Re: Westwinds Master Development Plan **MDP # 808-E**

The City Staff Development Review Committee has reviewed the Westwinds Master Development Plan **M.D.P. # 808-E** and approved. Please note the following:

WESTWINDS
995.31 ACRE TRACT
MASTER DEVELOPMENT PLAN AMENDMENT 808-E

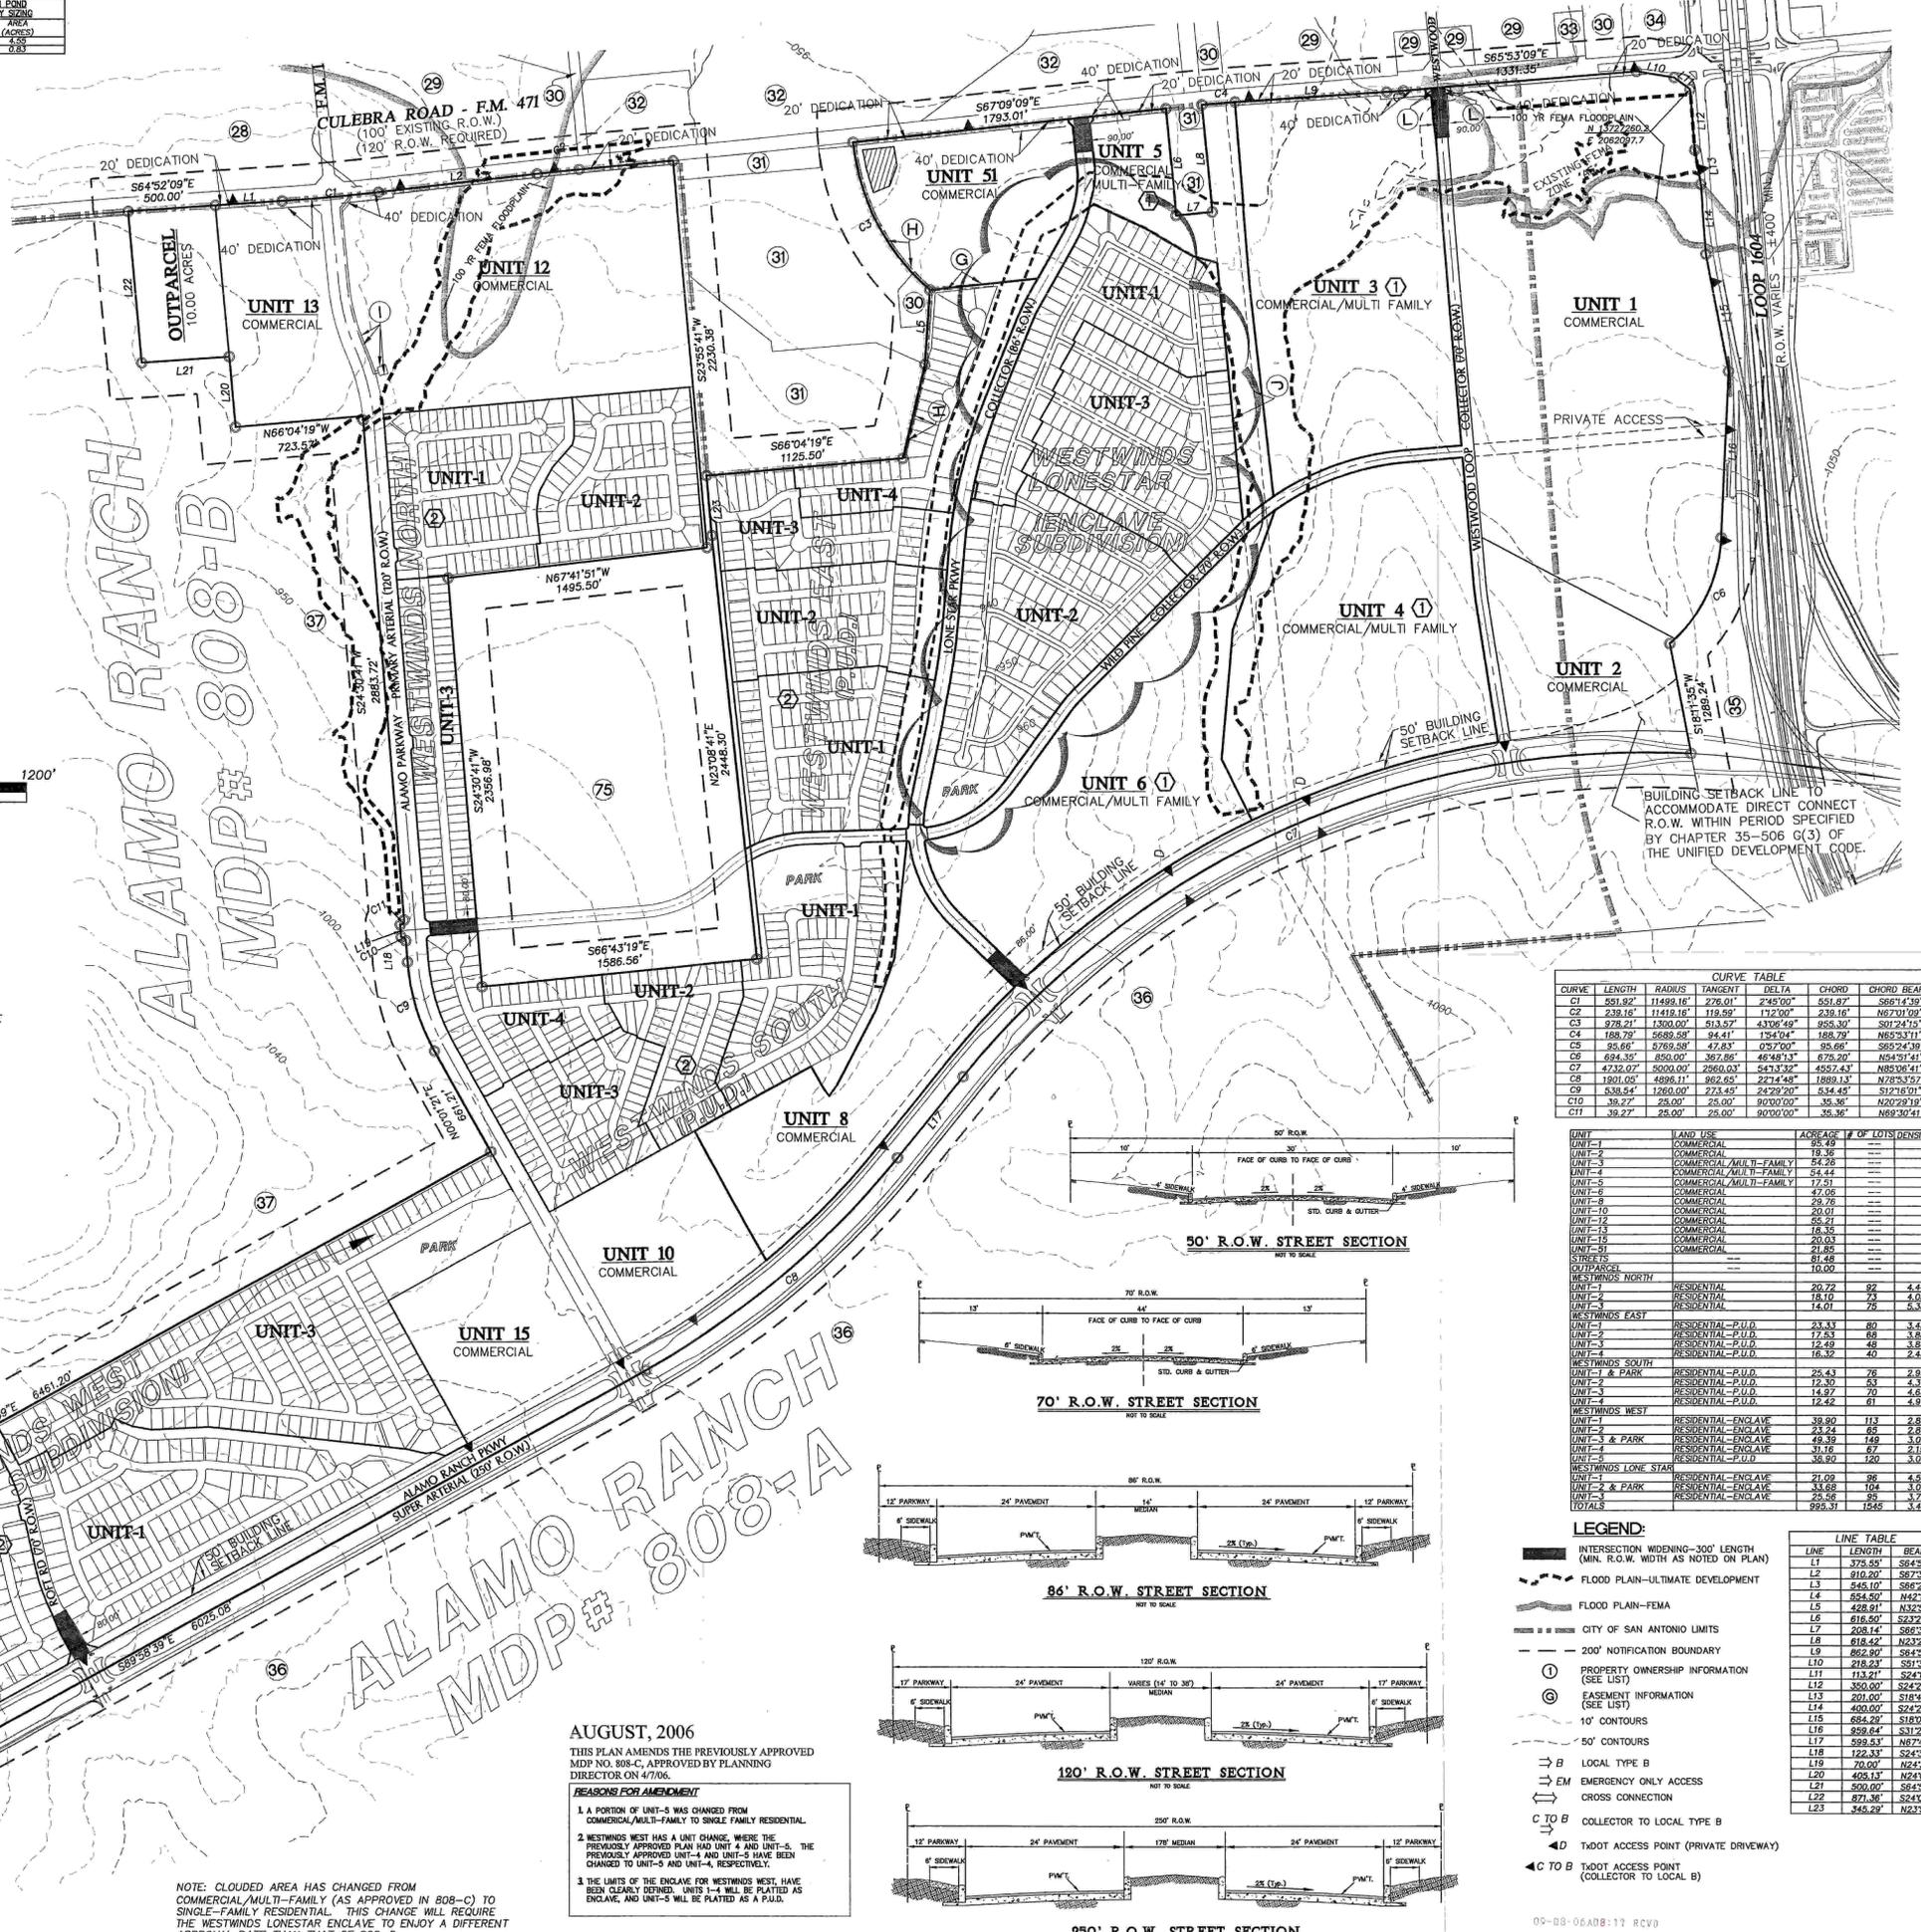
In consideration of public safety and convenience, excessive grades by reason of topography should be avoided in street layouts and arrangements.

Any access and R.O.W. issues along state facilities will need to be resolved with the **Texas Department of Transportation (TXDOT)**. For information about these requirements you can contact TXDOT at 615-5814.

DSD – Traffic Impact Analysis & Streets indicate that under the UDC listed below are some of the requirements and onsite improvements that are necessary and shall be provided by the developer, on and before the completion of the Westwinds MDP, at no cost to the City of San Antonio:

- All roadways shall follow Table 506-7, Functional Classification System Description and shall comply with UDC 35-502(a)(9)
- All sidewalks shall comply with UDC 35-506(q)
- Driveway throat lengths shall comply with UDC 35-506, Table 506-7
- All access driveways shall comply with UDC 35-506(r)
- Right turn and left turn lanes will be required at the two entrances

Parks recommends approval with the following conditions:

- The multi-family portions of this development will need to submit detailed plans at time of platting in order to determine their park dedication requirement.
- The Park/Open Space is to be dedicated to their respective Home Owners Associations and a Provision and Maintenance plan shall be submitted to this department at time of platting.
- The areas to be dedicated shall be labeled as either "Park" or "Open Space" at the time of platting.

The property must be platted in accordance to the UDC and the Major Thoroughfare Plan to reflect the approved MDP. It is suggested to work closely with the school district, so they can plan accordingly.
